LIST OF FIGURES

b. Heatup and Cooldown Limit Curves for Normal Operation

FIGURE TS 3.1-1
KEWAUNEE UNIT NO. 1 HEATUP LIMITATION CURVES
APPLICABLE FOR PERIODS UP TO 33⁽¹⁾ EFFECTIVE FULL-POWER YEARS

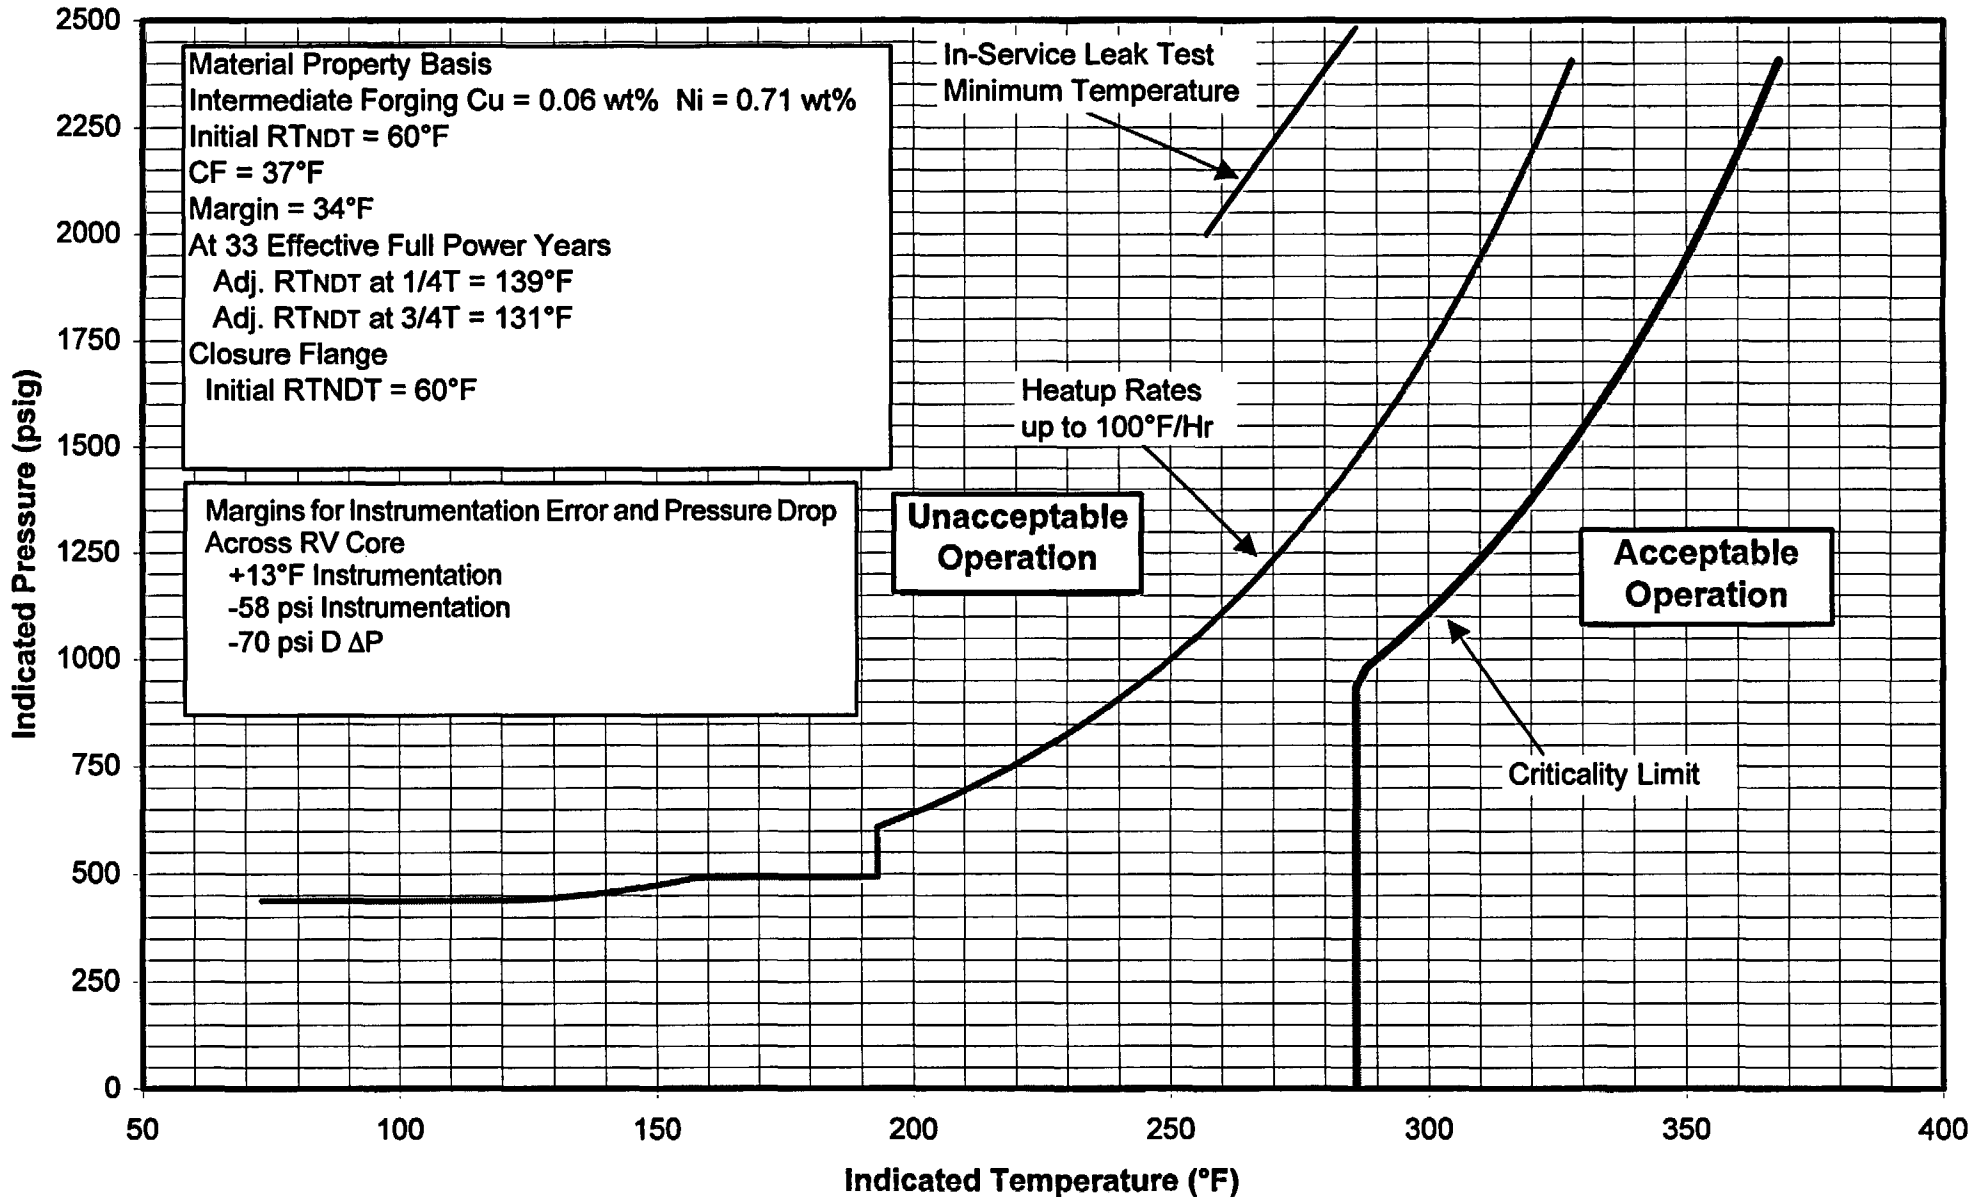
1. The reactor coolant temperature and pressure and system heatup and cooldown rates (with the exception of the pressurizer) shall be limited in accordance with Figures TS 3.1-1 and TS 3.1-2. Figures TS 3.1-1 and TS 3.1-2 are applicable for the service period of up to 33⁽¹⁾ effective full-power years.

⁽¹⁾The curves are limited to 31.1 EFY due to changes in vessel fluence associated with operation at uprated power.

**FIGURE TS 3.1-2
KEWAUNEE UNIT NO. 1 COOLDOWN LIMITATION CURVES
APPLICABLE FOR PERIODS UP TO 33^[1] EFFECTIVE FULL-POWER YEARS**

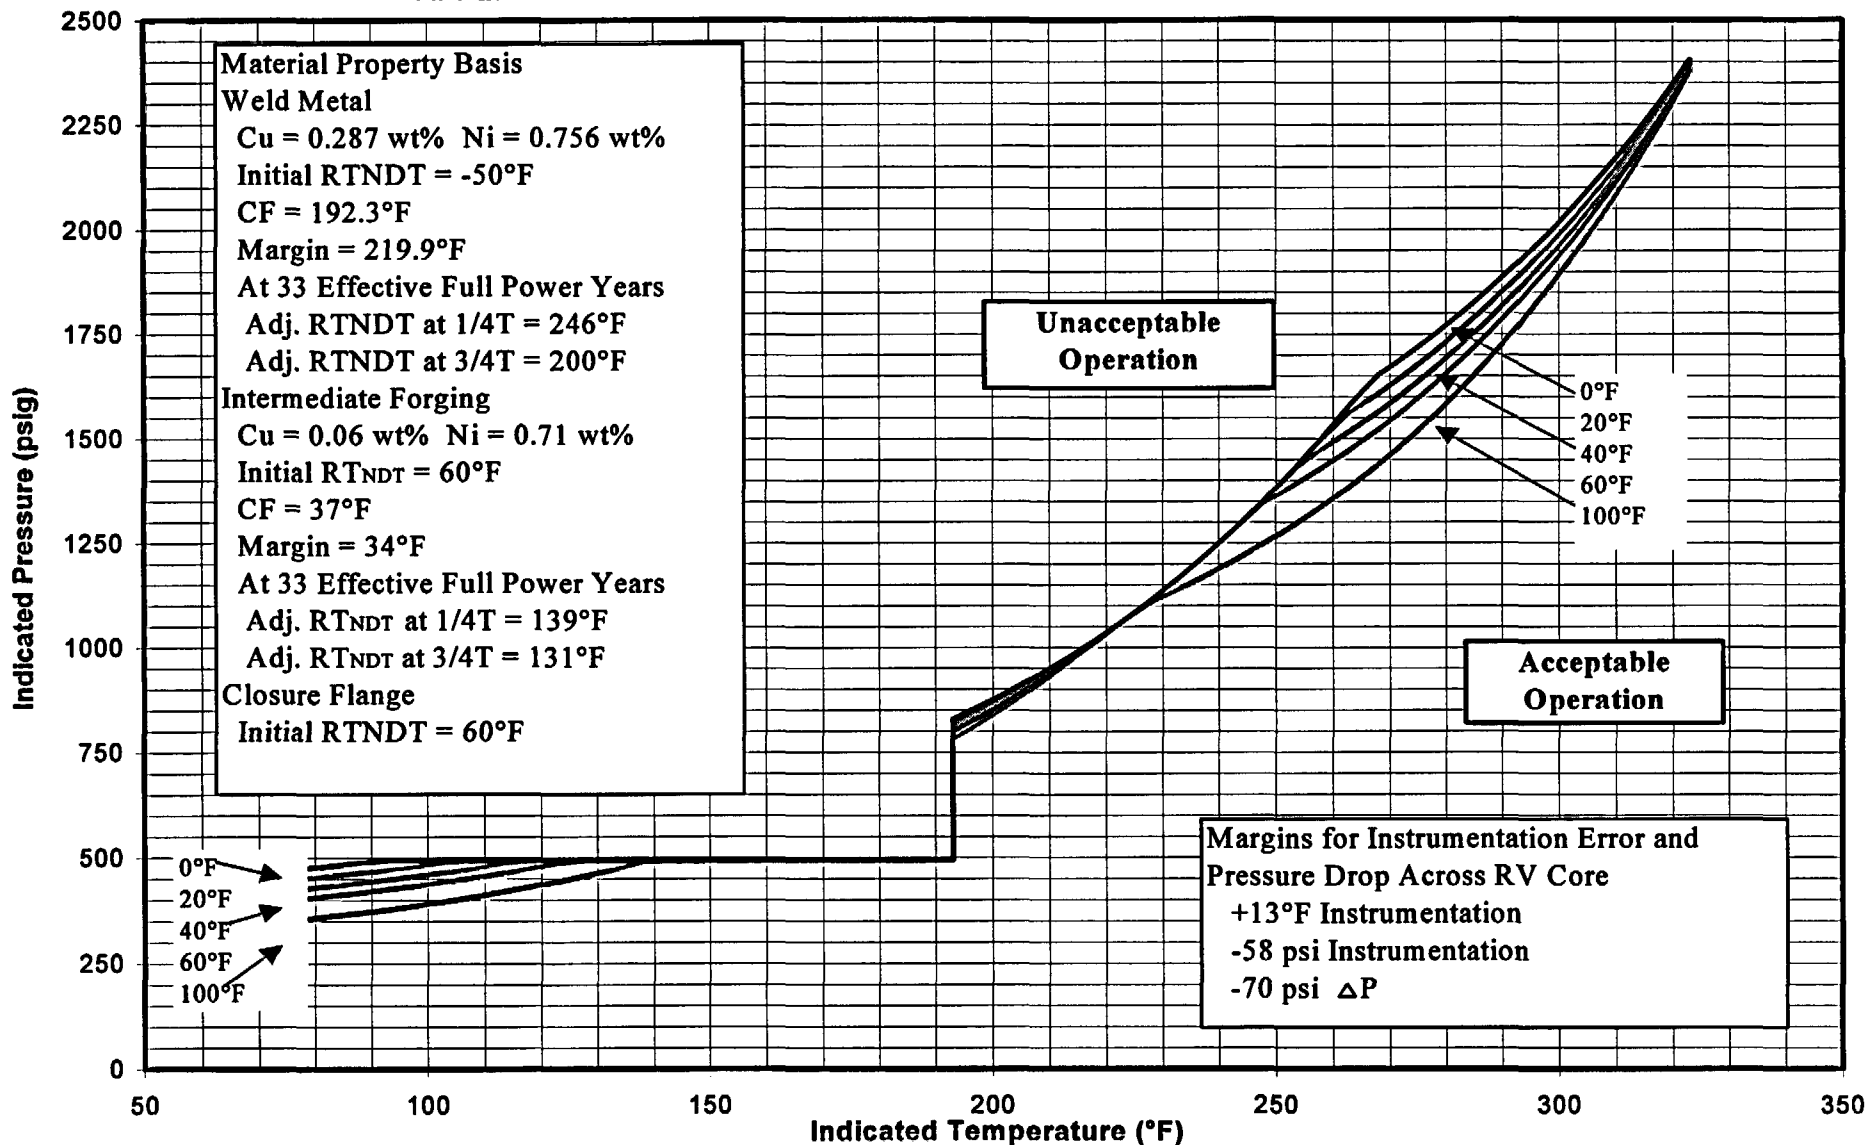
- C. The isothermal curve in Figure TS 3.1-2 defines limits to assure prevention of non-ductile failure applicable to low temperature overpressurization events only. Application of this curve is limited to evaluation of LTOP events whenever one or more of the RCS cold leg temperatures are less than or equal to the LTOP enabling temperature of 200°F.

^[1] The curves are limited to 31.1 EFPY due to changes in vessel fluence associated with operation at uprated power.
